Re: Design Exception #DE 19-05 – Site Access for 1215 N. 1st Street

DESIGN EXCEPTION #DE 19-05

RE: Site Access for 1215 N. 1st Street

1215 N 1st

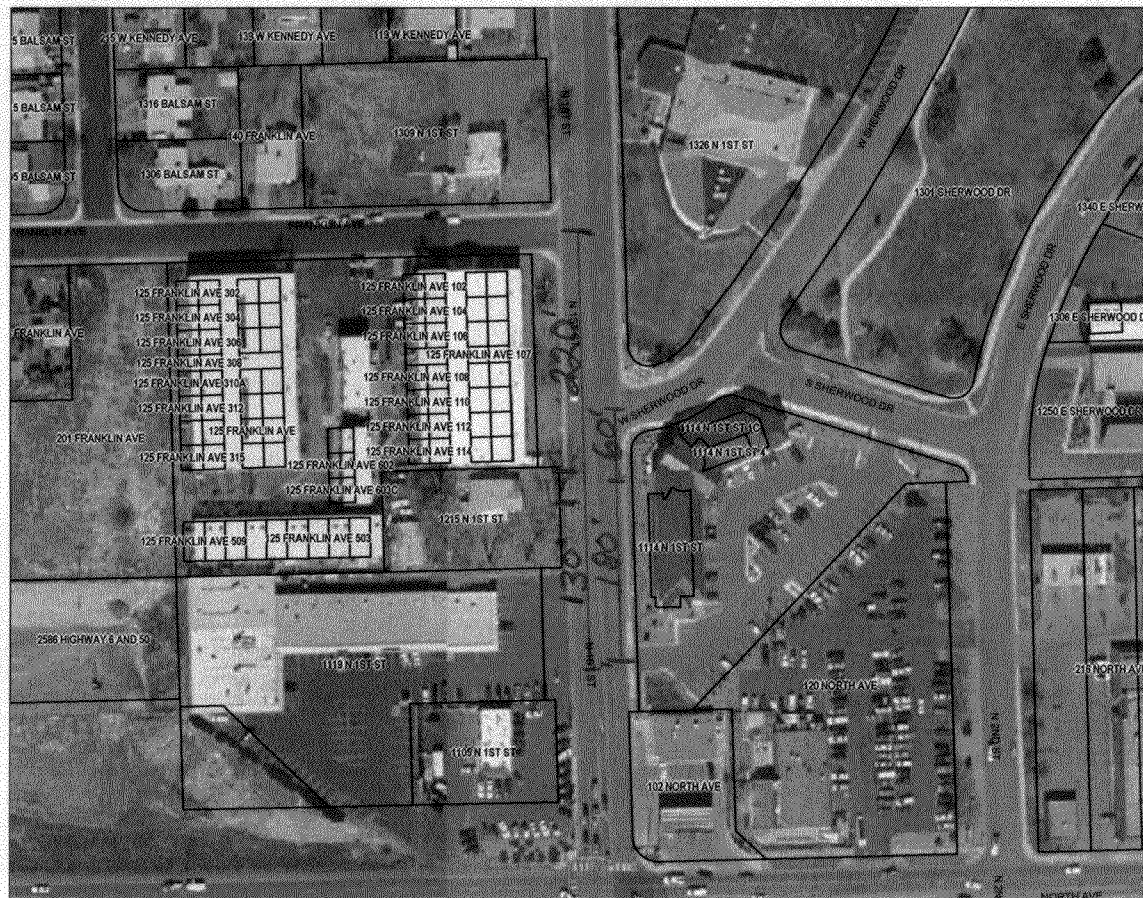
- MINOR ART. → 300' OFFSET
- ACCESS ≥ 28'
- STACKING ≥ 25'

Sheet: **C1.0**
 Site Plan
 Drawn by: K. Kautzen

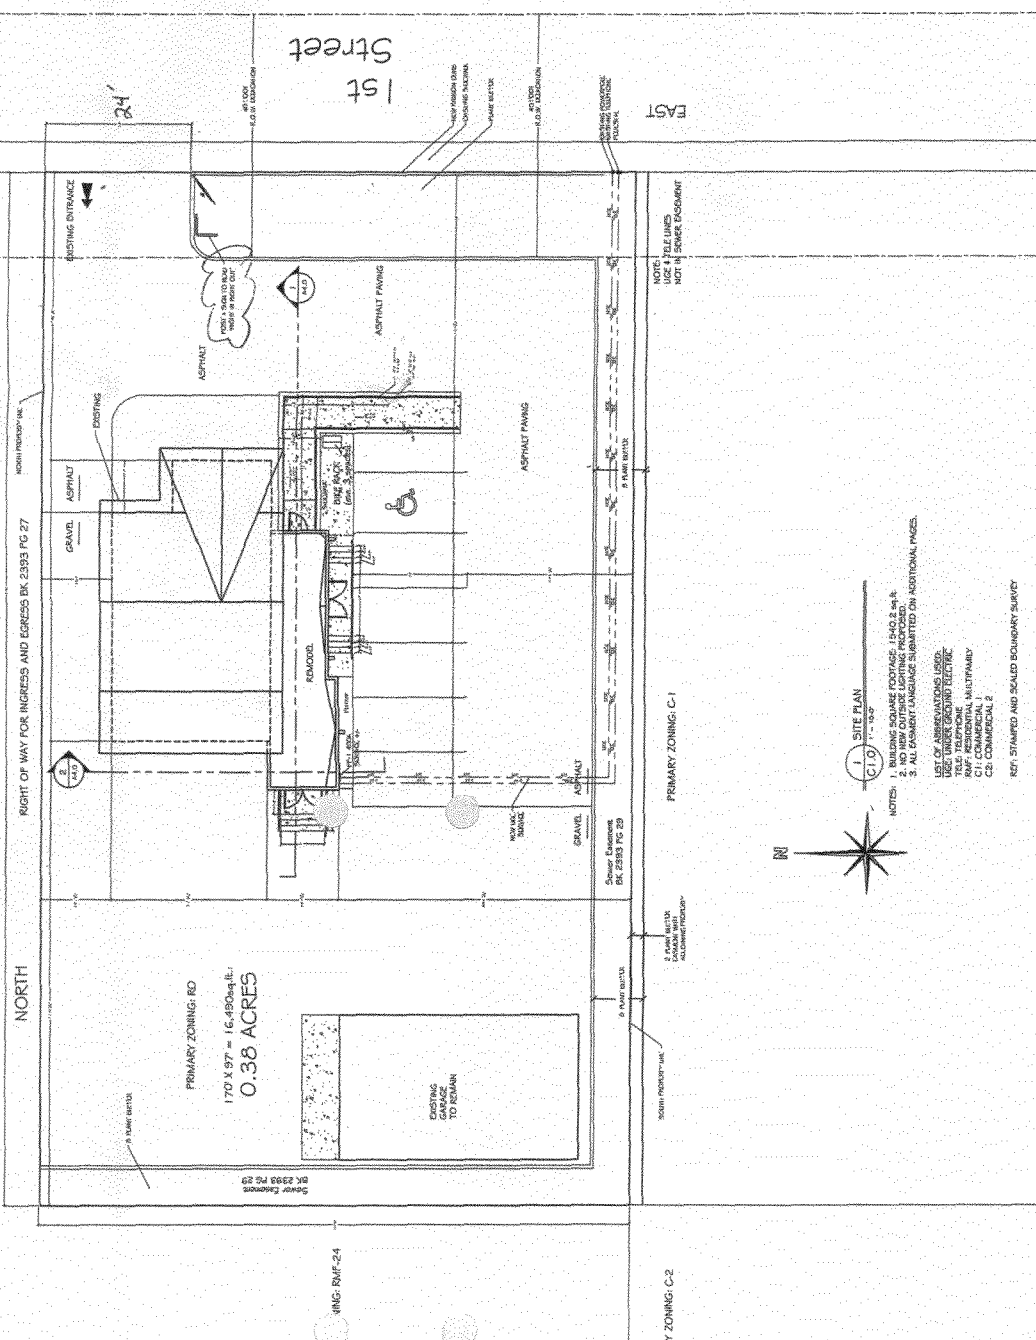
1. The access location does not meet the minimum spacing distances from adjacent accesses and intersections on the same side of 1st Street, including Franklin Ave and the access to the small strip mall to the south. For Minor Arterial streets, the minimum distance is 300'. The current site plan provides a distance of 220' to the northern intersection at Franklin and provides a distance of 160' to the southern driveway at the strip mall.

2. The access location does not meet the minimum offset distance from opposing accesses and intersections. The minimum distance in TEDS is 300' for opposing driveways. The current site plan provides a distance of 60' to West Sherwood Dr. and a distance of 180' to the convenience store to the south.

3. The access width does not meet the minimum access width for a commercial use. TEDS requires a minimum width of 28'. The current site plan provides a 24' driveway width.

4. The access throat length does not provide the minimum vehicle storage length. For this use, the minimum length is 25'. The existing throat length is approximately 20'.

Proposed Design: With the utilization of the current driveway plus approximately 8' of driveway access north of the "right of way for egress line" and by setting back the ribbon curbing by an addition 4' the 28' minimum access width requirement can be achieved.

Response: The required vehicle storage stack up requirement has been met if you include the north/south corridor next to the parking lot. The site plan provides parking for four regular and one handicap parking spaces. The entire throat length including the north/south corridor provides space for five vehicles also.
